REVISED PROPOSED REPLACEMENT

SEPTIC SYSTEM PLAN

PREVIOUS APPROVAL #CA2001035569

LOCUS: 76 WINNICUT ROAD
NORTH HAMPTON, NH

CROSS SECTION DISPOSAL SYSTEM – NOT TO SCALE

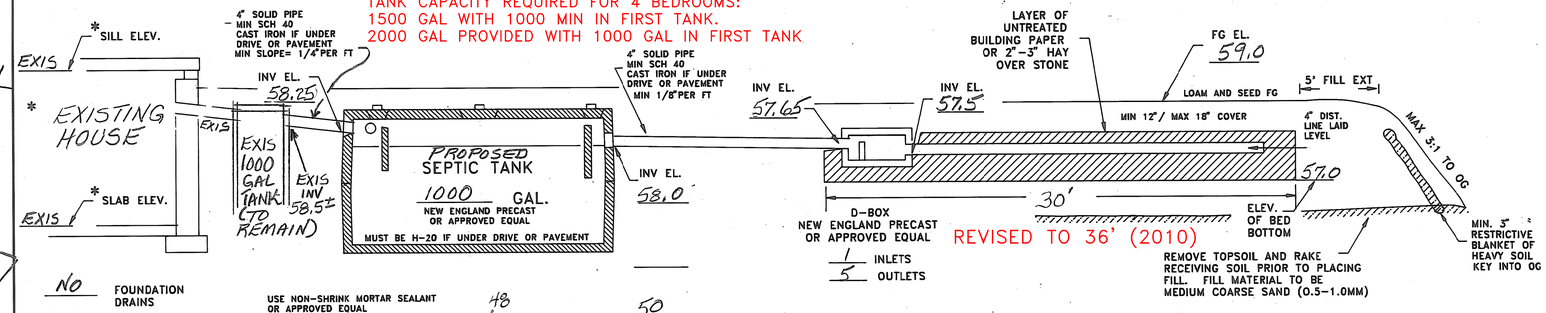
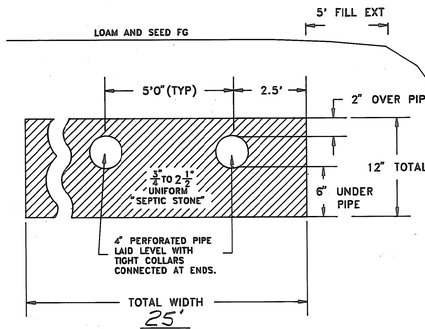
57.0
MAX 3:1 TO OG
30'
ELEV. OF BED BOTTOM
REVISED TO 36' (2010)
REMOVE TOPSOIL AND RAKE RECEIVING SOIL PRIOR TO PLACING FILL. FILL MATERIAL TO BE MEDIUM COARSE SAND (0.5–1.0MM)
MIN. 3' RESTRICTIVE BLANKET OF HEAVY SOIL KEY INTO OG
NO FOUNDATION DRAINS
USE NON-SHRINK MORTAR SEALANT OR APPROVED EQUAL

PLOT PLAN

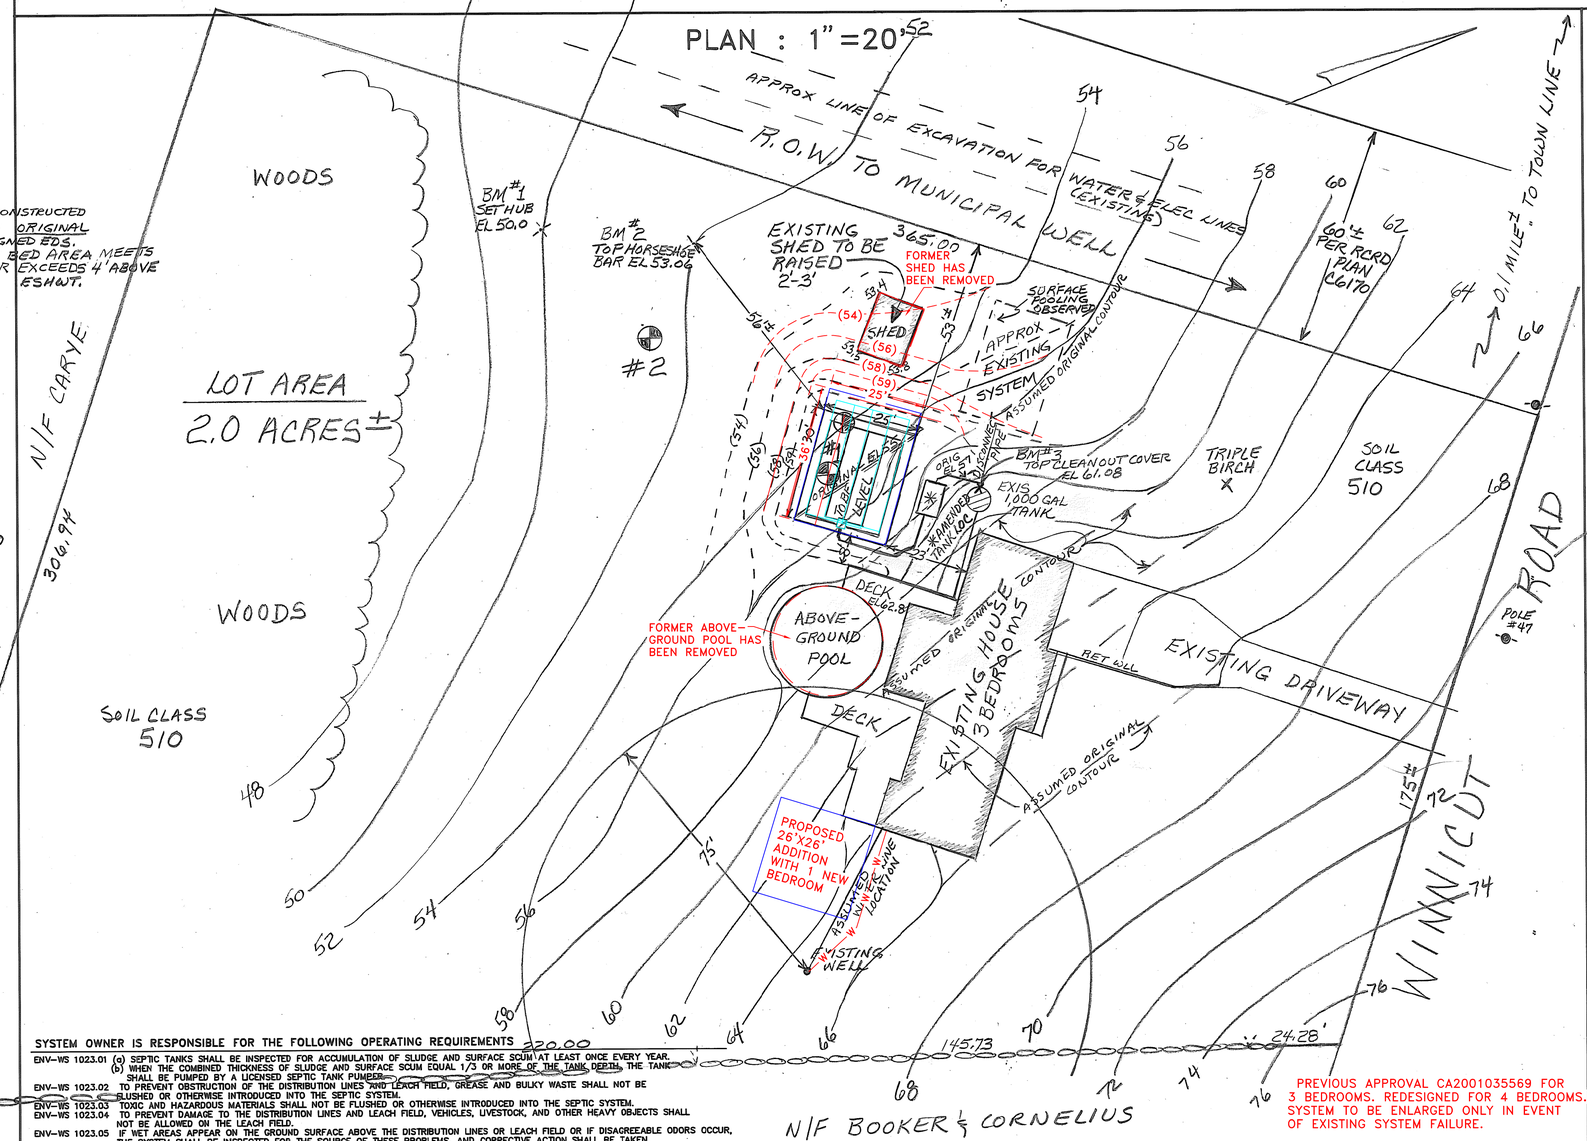
PREVIOUS APPROVAL CA2001035569 FOR 3 BEDROOMS. REDESIGNED FOR 4 BEDROOMS. SYSTEM TO BE ENLARGED ONLY IN EVENT OF EXISTING SYSTEM FAILURE.

REVISED APRIL 16, 2010 FOR 4 BEDROOM DESIGN LOADING
@6 MIN/IN PERC, 900 SF LEACH FIELD AREA REQUIRED
ADD 6' TO APPROVED/EXISTING FIELD FOR 25 X 36 = 900 SF PROVIDED.
